CHICK-FIL-A POWERS & PALMER

Site Development Plan

Merrick comment response noted in blue text box with white background

SHEET
SITE PLAN

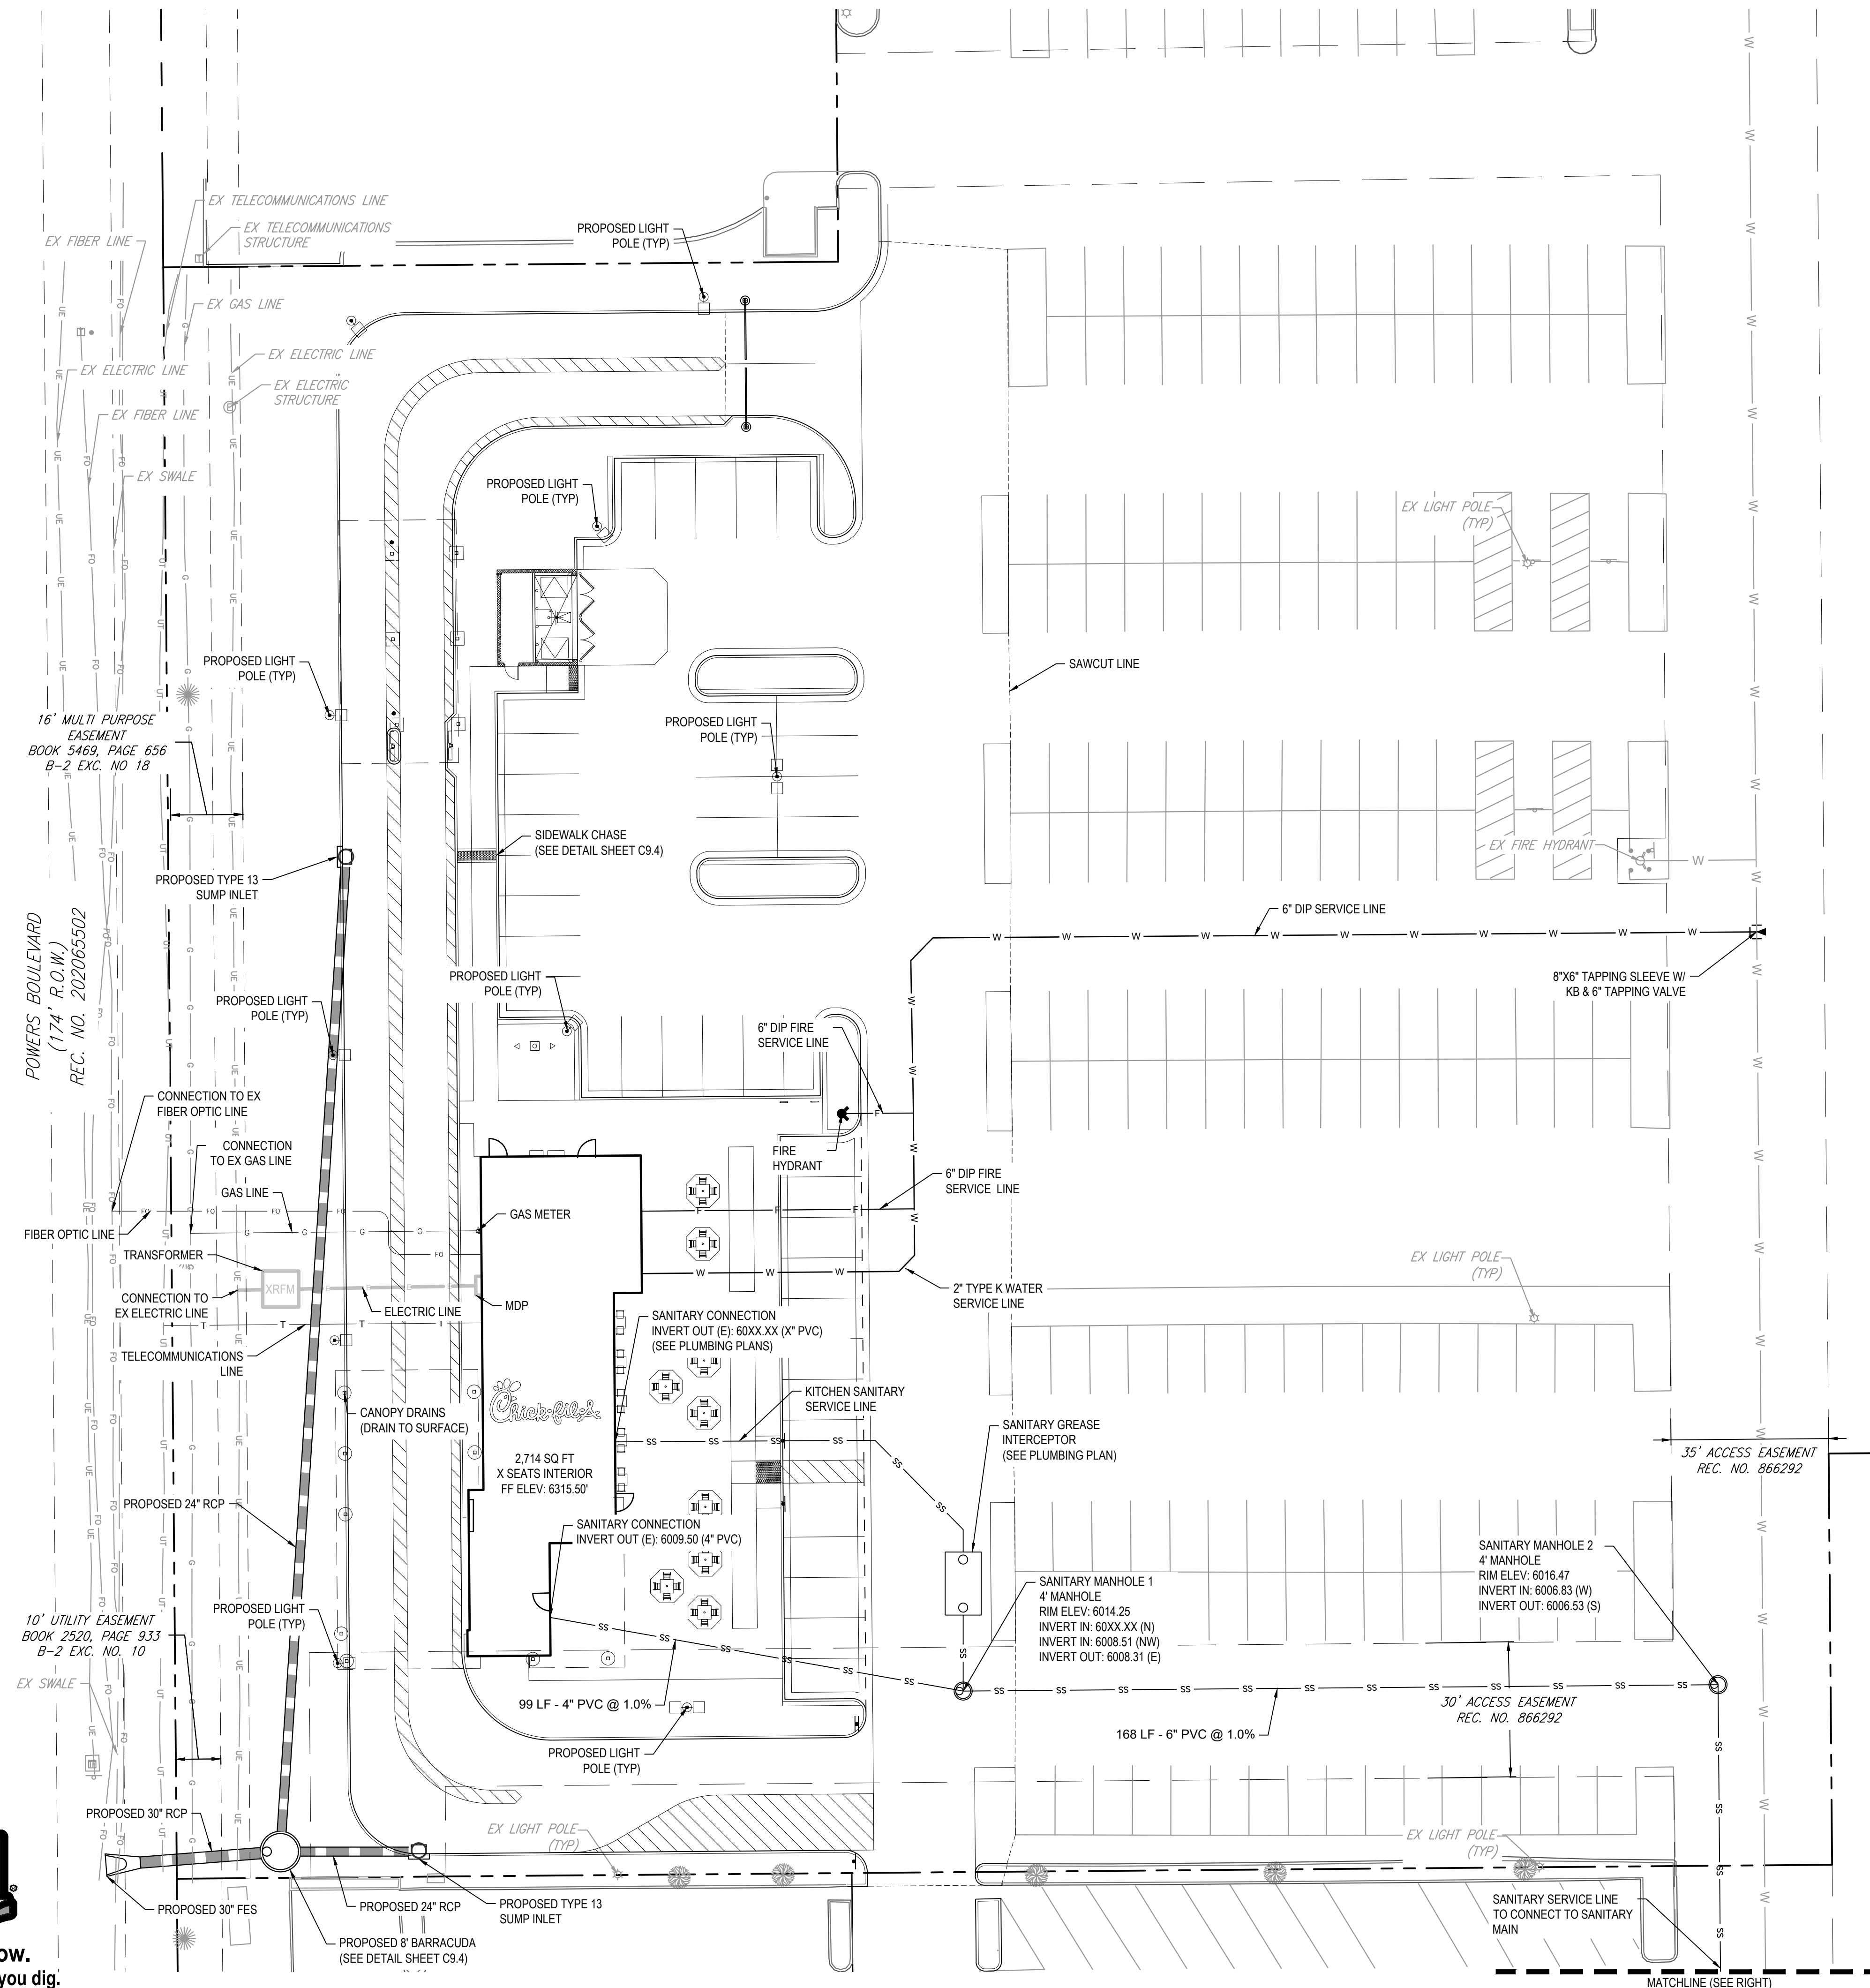
Label adjacent property
LOT 2 BLK 1 WALDORF SUB
Parcel 5406304001

call out existing or
proposed

Is this zero seats
interior? Please
correct to zero (0)

Label adjacent
property

Provide parking analysis
for the complete property
and all uses to include
the fitness center in LOT
#1

Provide a Pedestrian Access
Route along Palmer Park into lot
and site IAW ECM Chpt 6
requirements. Sidewalks are
missing along frontage.

Depict traffic circulation flow in and out of property to
adjacent public streets and access point

Pursuant to the Site Development
Plan checklist at the link below,
please include a table calculating
open space, landscaping, and
impermeable surface percentage.

Please clarify. The
plan only depicts 38
spots and 2 ADA
spots.

ADJACENT
PROPERTY
LABELED AND
PROPOSED AND
EXISTING CURB
CALLED OUT

ADJACENT
PROPERTY
LABELED

THE PARKING ANALYSIS IS
IN PROCESS WITH THE
LANDLORD AND ADJACENT
LOT INCLUDING THE
FITNESS CENTER

OUR CIVIL SITE
SCOPE DOES
NOT
ENCOMPASS
IMPROVEMENTS
ALONG PALMER
PARK BLVD. LOT
2 BLOCK 1 IS
ALONG PLAMER
PARK BLVD

THE TRAFFIC
CIRCULATION
FLOW IS IN
PROCESS WITH
THE LANDLORD
AND ADJACENT
LOT INCLUDING
THE FITNESS
CENTER

SITE DEVELOPMENT PLAN
PROJECT DATA TABLE
UPATED PER THE SITE
DEVELOPMENT PLAN
CHECKLIST

PARKING
COUNT
CLARIFIED
